Midland Railway Workshops site, Helena East Precinct: Review of reports relating to hydrogeology of the site and potential impacts of groundwater contaminants on the Helena River.

**Report to ATA Environmental for Midland Redevelopment Authority
by Crisalis International Pty Ltd**

June 2005

Review and Recommendation on Groundwater Monitoring at Helena East Precinct, Midland Railway Workshops: Report to ATA Environmental for Midland Redevelopment Authority.

Figure 1. Reported groundwater level contours for the Shallow Superficials^(1,2,6).

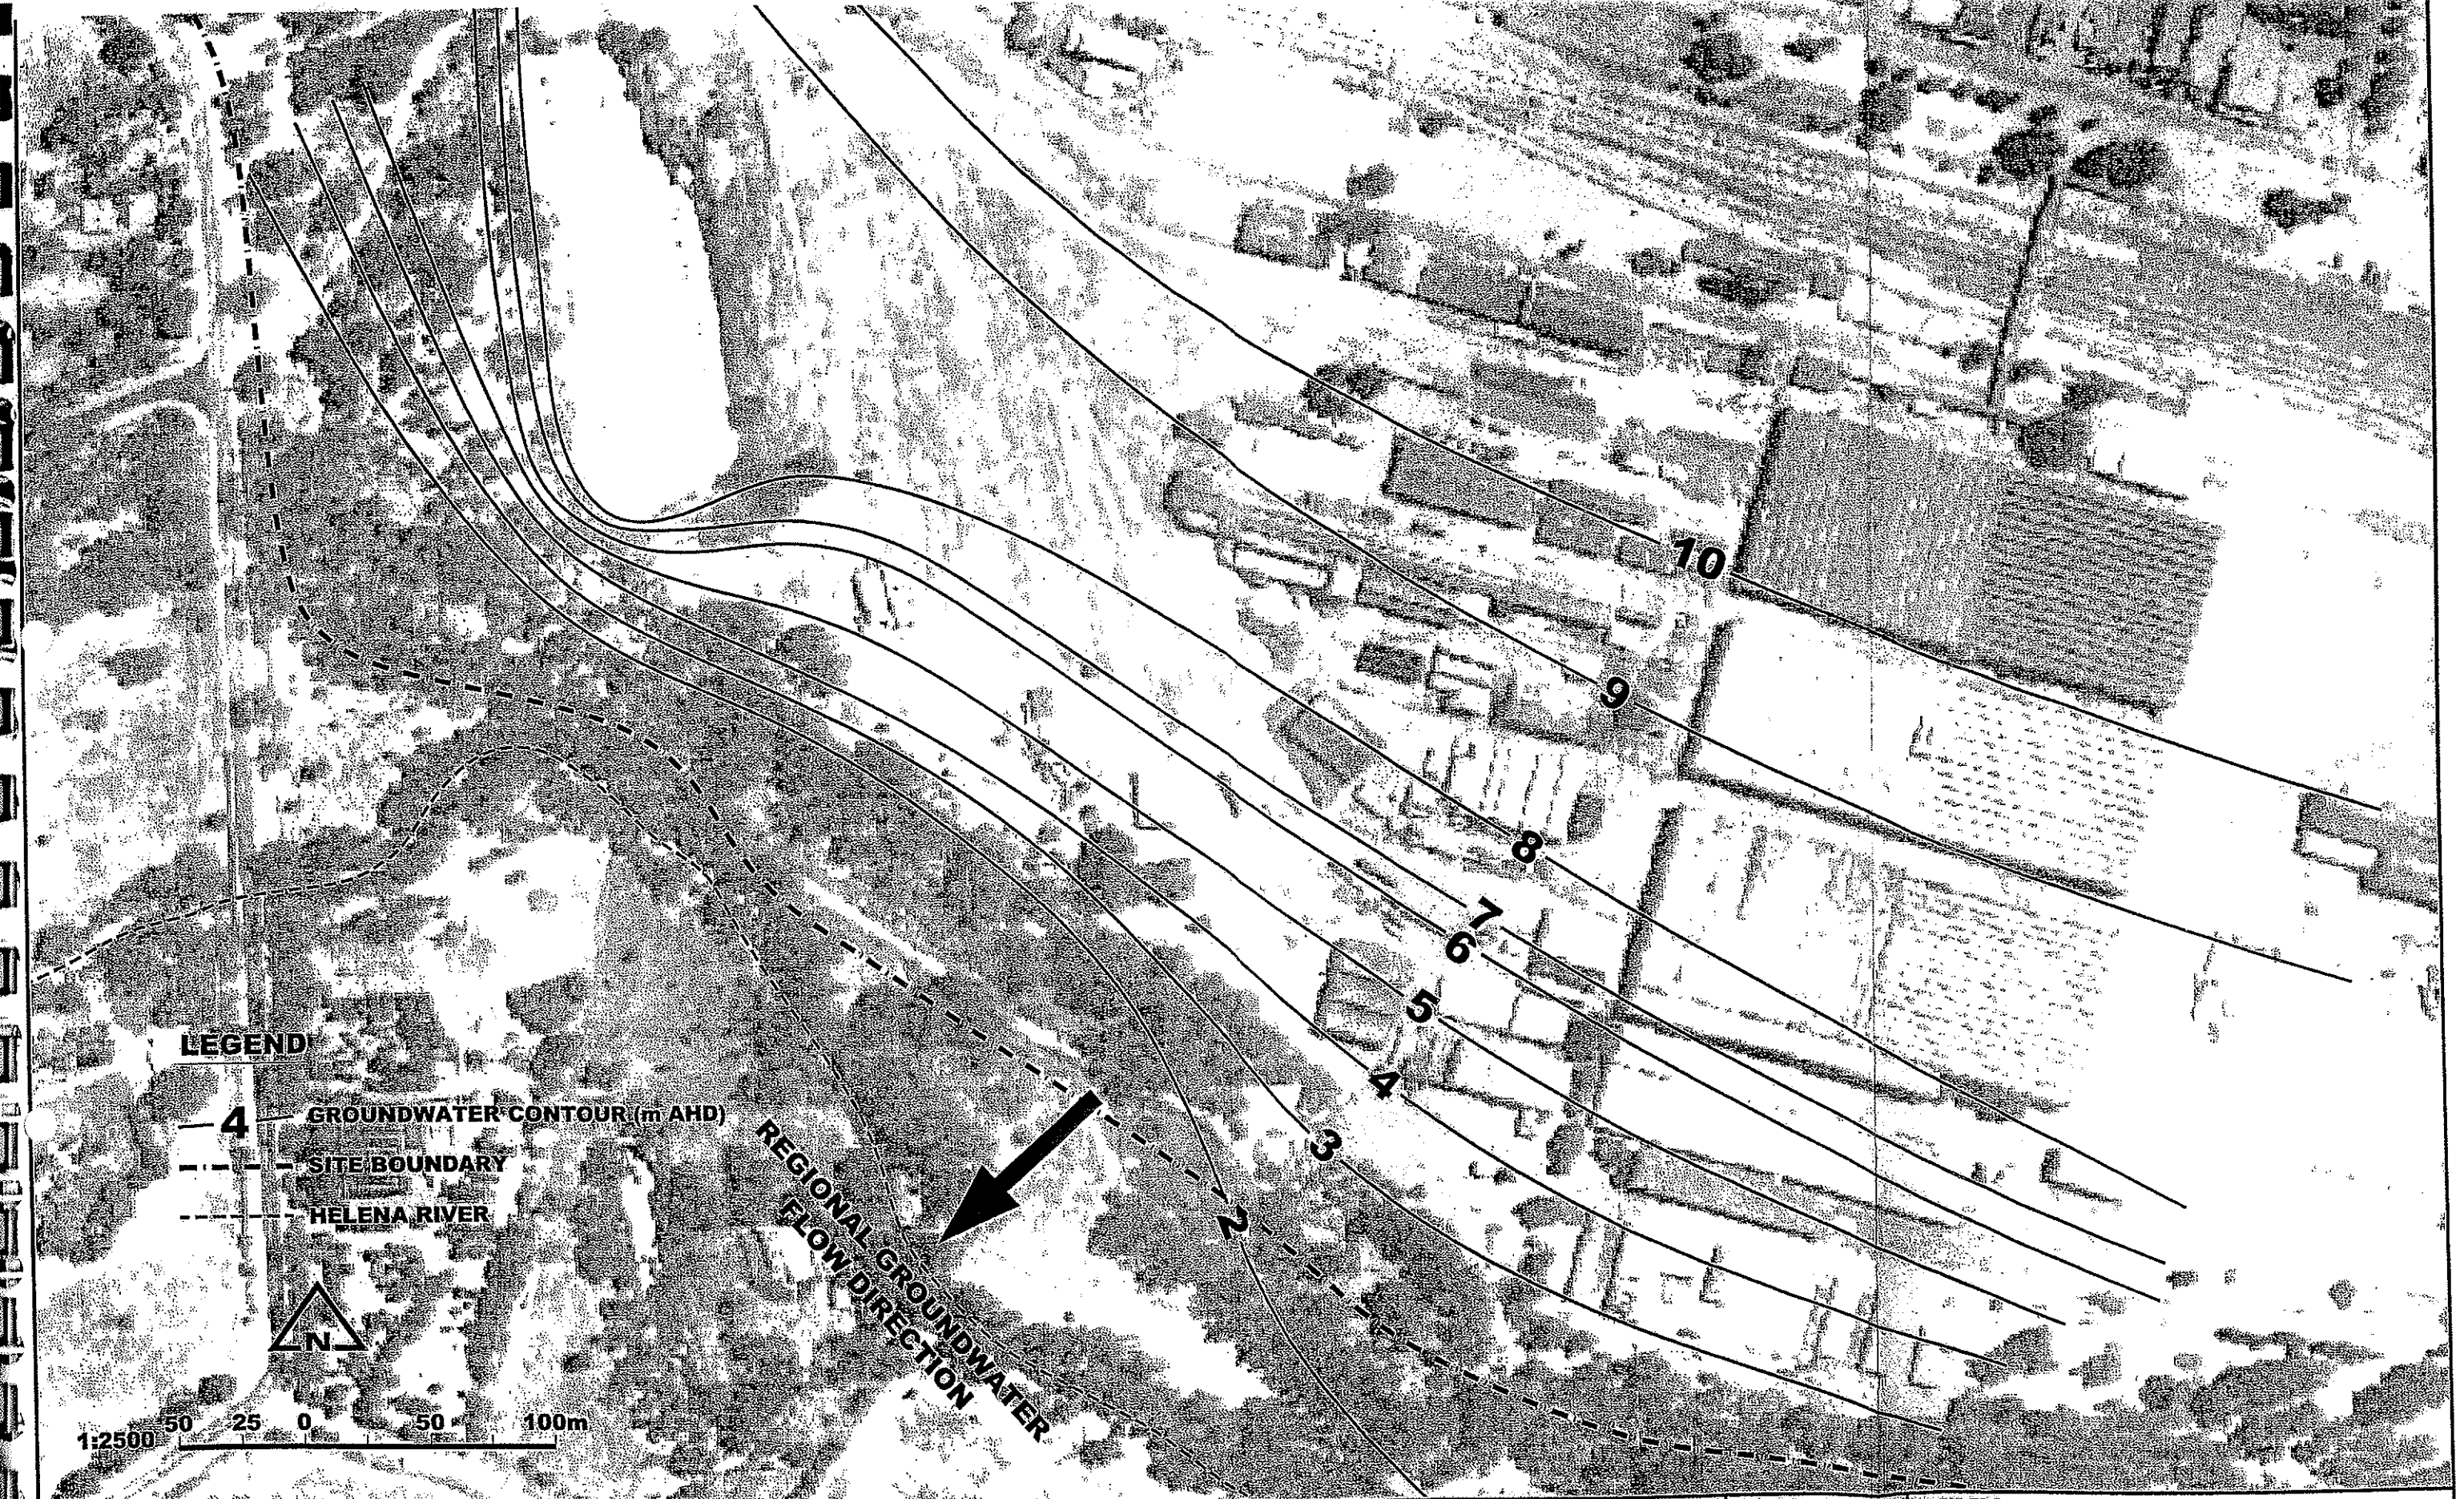
Earlier reports by ENV Australia ^(1,2) indicate that shallow groundwater below the site in sand and silt lenses within clayey soil sequences, flows broadly towards the southwest and the Helena River (see Figure 3, ENV 2002^(2,6), and Figure 1 here). The latter conclusions would seem to be based on groundwater level data in shallow superficial deposits, although the source and original data is not provided in the above reports.

The more permeable sands in the deeper parts of the Superficial (Guildford) Formation do show a uniform hydraulic gradient and groundwater flow approximately west-north-west⁽³⁾ and not towards the Helena River, as indicated in the ENV(2003) report ⁽³⁾. Hydraulic conductivities measured from the pumping test ⁽³⁾ showed a mean value of 7m/d, similar to the average for the Guildford Formation of 3m/d (Davidson, 1995). The determined storativity⁽³⁾ was quite low which indicated confined, or more probably semi-confined groundwater conditions within this part of the aquifer. The lack of response of bore WP1 in the Shallow Superficials which was monitored during the pumping tests, provides additional evidence of a poor hydraulic connection between the Shallow and Deep Superficials, thus supporting the conclusion that these behave as separate aquifer systems, although there may be some vertical connectivity in places. Groundwater in the shallow sediments seems more likely to move and transmit contamination laterally under the imposed hydraulic gradient in the interpreted flow conditions implied in Figures 1 and 2 here.

Figure 2. Approximate groundwater level contours around and to the east of the Coal Dam in the Shallow Superficials, based on water levels given in ENV(2003)⁽³⁾ (shown for each bore within this aquifer unit).

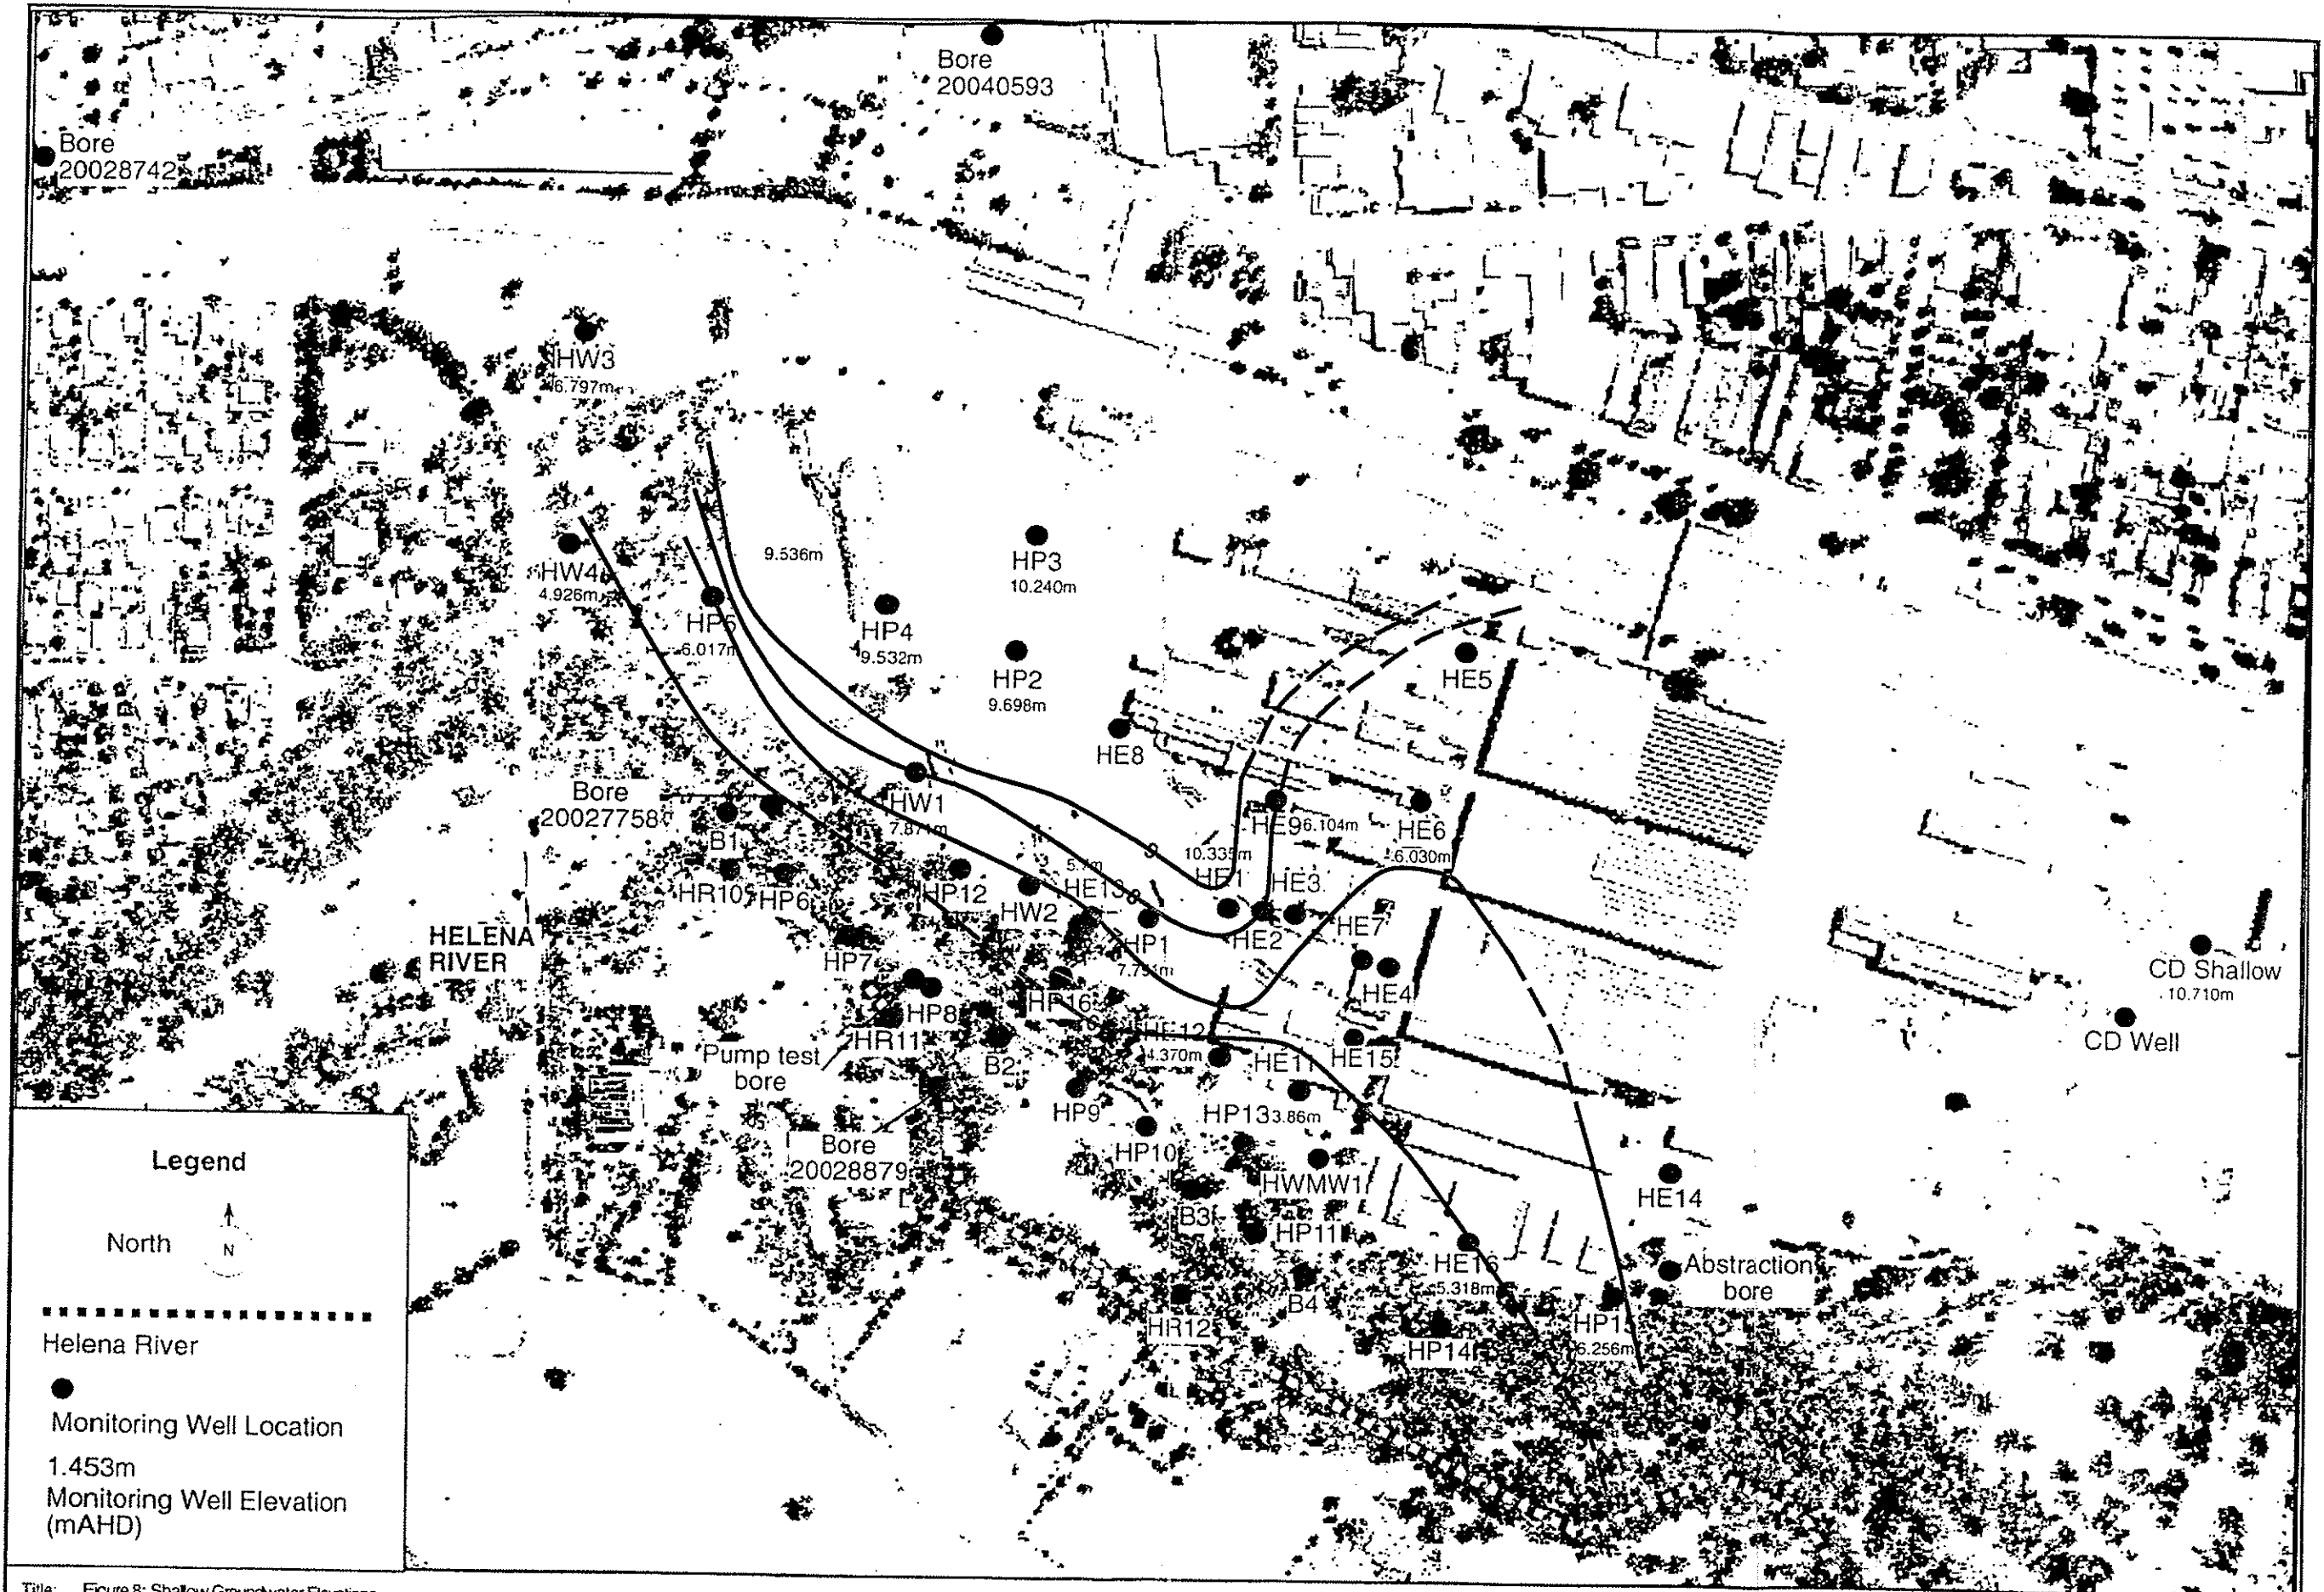
Approximate contouring of groundwater levels from data shown in Figure 8 in ENV(2003)⁽³⁾, shown in Figure 2 in this report, suggests there is a reasonably uniform flowfield which is dominated by what seems to be a non-symmetric recharge mound towards the southeast of the Coal dam. There is also a broad groundwater movement to the southwest towards the Helena River from the site. These approximate contours, shown here in Figure 2 in this report, are very similar to the interpreted flowfield shown in earlier ENV reports^(1,2,6) and shown here in Figure 1. In particular, these suggest that the Coal dam and groundwater within the more permeable sand/gravel horizon are in hydraulic continuity, and that the Shallow Superfcials act as a single (but complex) aquifer system. These would indicate some potential for movement of groundwater within the Upper Superfcials towards the Helena River.

Earlier detailed investigation of the hydrogeology of the dam by Dames and Moore (1997)⁽⁷⁾, suggested groundwater mounding around the dam which indicates that the dam was recharging groundwater. The approximate contours shown in Figure 2 here suggest some mounding to the southeast.
